PREPARED FOR THE PLAN COMMISSION

Project Address: 3801 Kipp Street (also addressed as 3757 Marsh Road)

Application Type: Conditional Use

Legistar File ID # 34334

METRO EXHIBIT

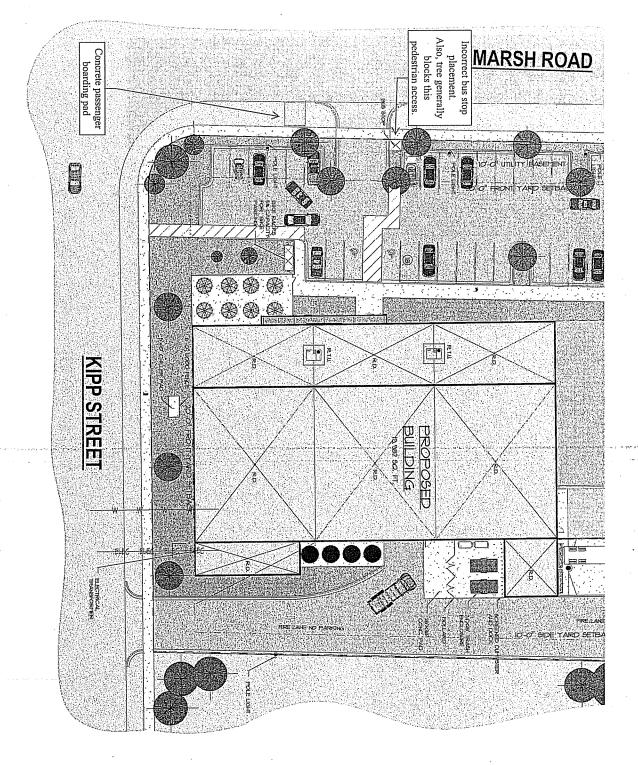
41. In coordination with public works improvements, the applicant shall install a new concrete passenger boarding pad on the east side of Marsh Road, north of Kipp Street. The concrete pad shall occupy the full distance of the terrace, measure a minimum of 10 feet in width parallel to the street, and lie flush between the sidewalk and the top of curb. The applicant shall include the location of these transit amenities on the final documents filed with their permit application so that Metro Transit may review and approve the design. [See attached Metro exhibit showing location of this improvement.]
